Technical Service Information

THM 4L80-E CONVERTER CLUTCH SHUDDER

Figure 1

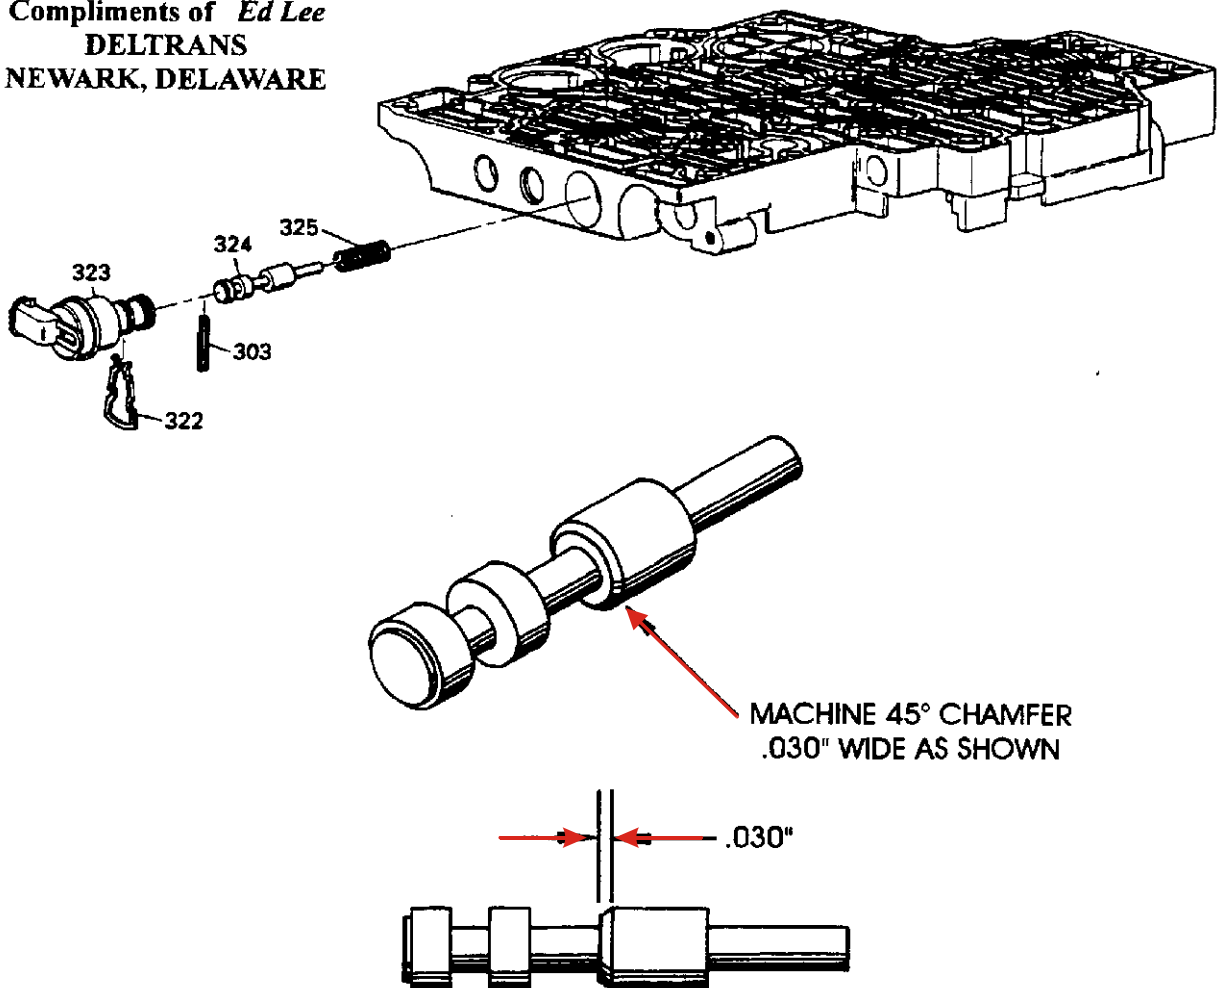
- COMPLAINT:** Before and/or after rebuild, the vehicle displays a Converter Clutch Shudder condition as the torque converter clutch is applying.
- CAUSE:** The cause may be, an inadequate amount of "Regulated Apply" oil to the converter.
- CORRECTION:** Machine a 45 degree chamfer that is .030" wide, on the TCC Regulator Apply Valve, on the land that is shown in Figure 1. This will allow more line pressure in to the TCC regulated apply circuit. Do not machine any wider than .030".
